MONTGOMERY COUNTY PLANNING DEPARTMENT
THE MARYLAND-NATIONAL CAPITAL PARK AND PLANNING COMMISSION

MEMORANDUM

REVIEW TYPE: Preliminary Forest Conservation Plan No. 0904-DGS-1
White Oak Recreation Center Mandatory Referral

Figure 1

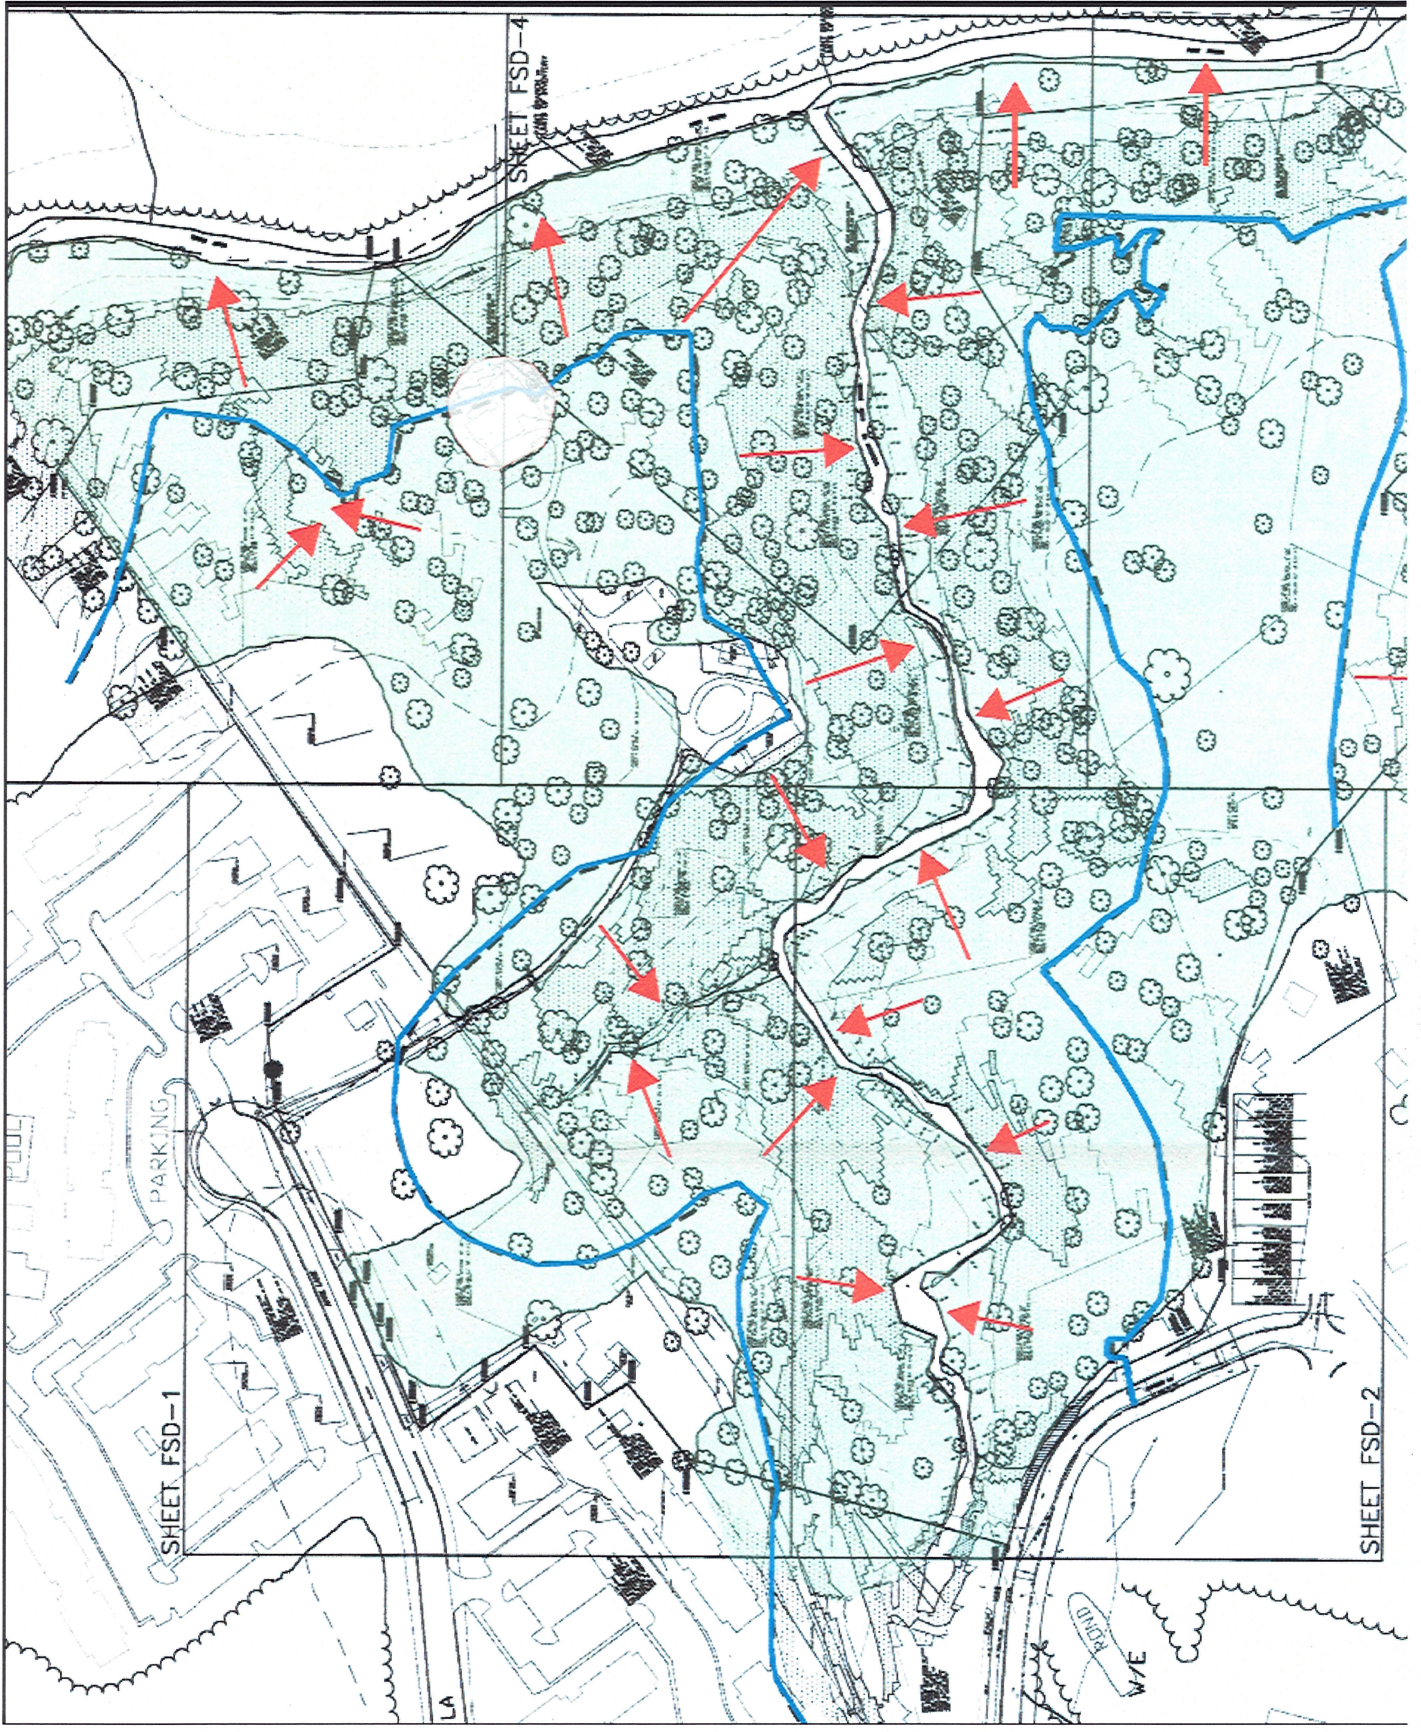
This location was chosen for use as a recreation center before the full extent of sensitive environmental features was known. Of the initial 50.33 acre site chosen for analysis, 44.48 acres is covered with sensitive environmental features - high priority forest or stream valley buffer. (see figure 1) Because the site is bisected by an unnamed tributary of the Paint Branch, with forested, steep slopes on each side, the decision was made to develop only a portion of the initial site. The portion selected is in the area of the stream valley park with the best roadway access and most available space for development. Of the final 22.09 acre site considered for development, 16.90 acres of the site is

Resolution: Environmental Planning supports the proposed development of a recreation center because of the clear need of the community for a recreation facility. The environmental impacts of the recreation facility need to be minimized and appropriately mitigated, but the development itself is necessary to serve the high density housing surrounding this site. While a less environmentally sensitive site would be preferable, both the County Council and Executive have chosen and funded the project in this location.

Figure 2

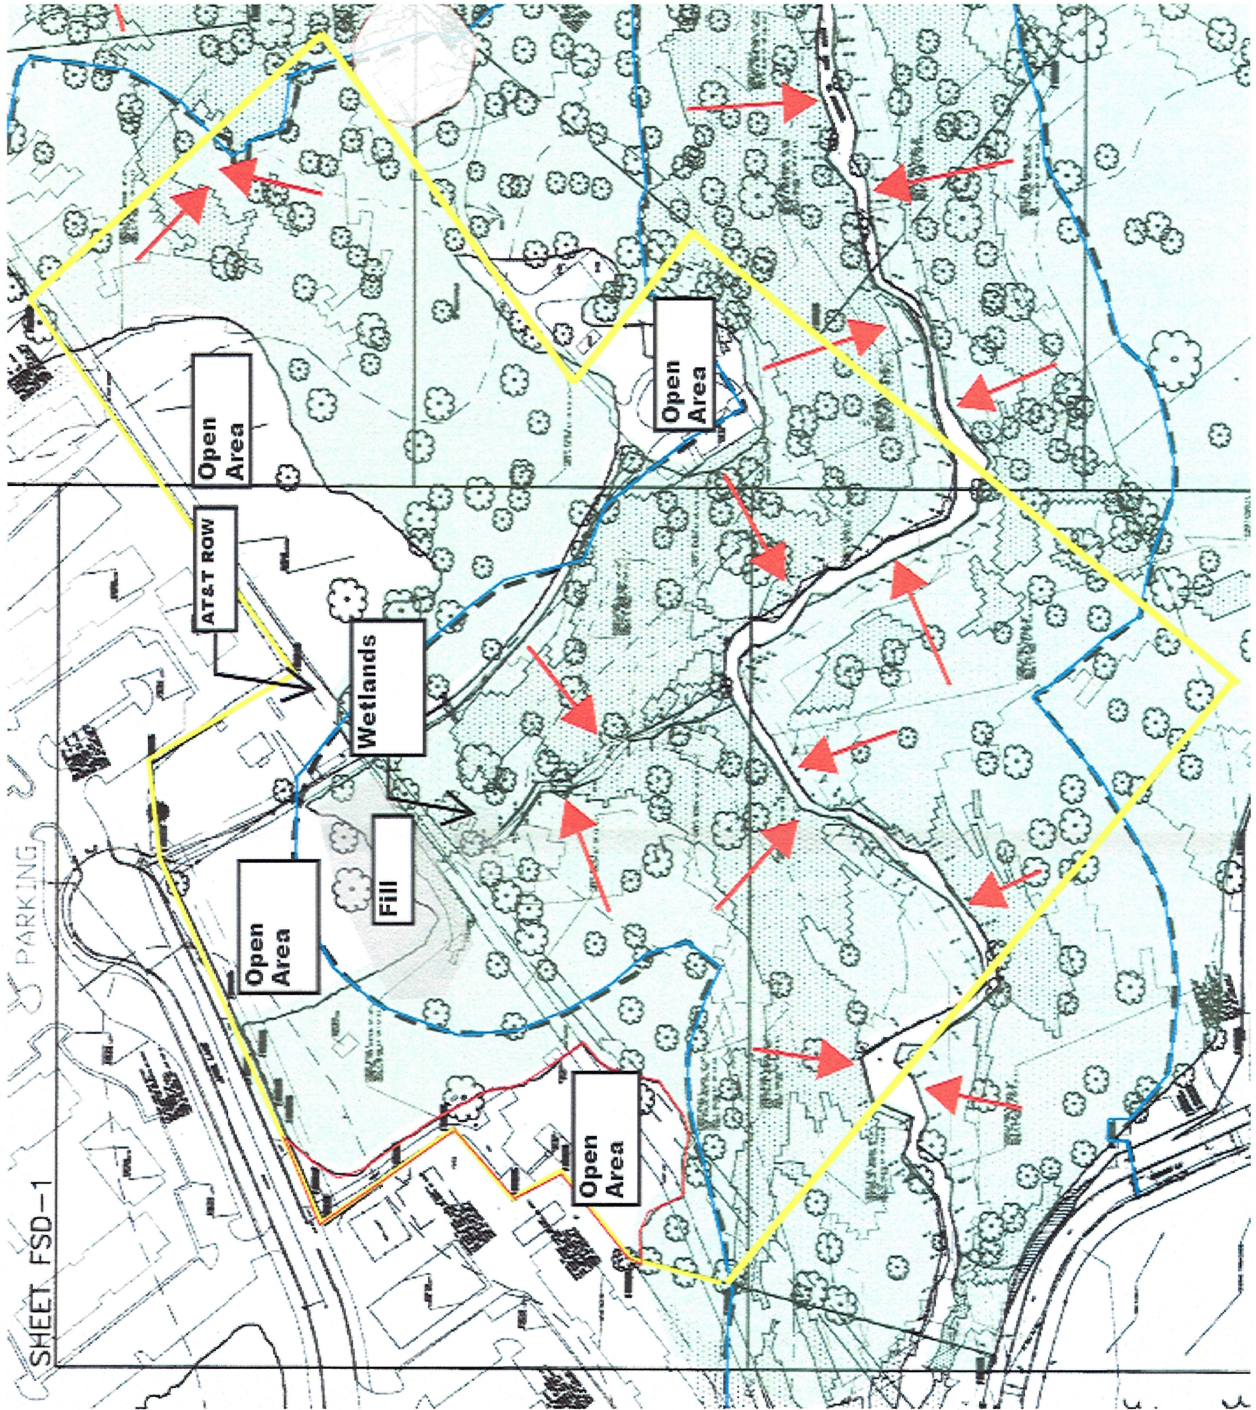
environmentally sensitive. The 5.19 acres of potentially developable area is further constrained by being separated by intervening areas of high priority forest. The property is further encumbered by an AT&T ROW, which restricts the type of development that can occur over it and the depth of disturbance allowed. (Figure 2)
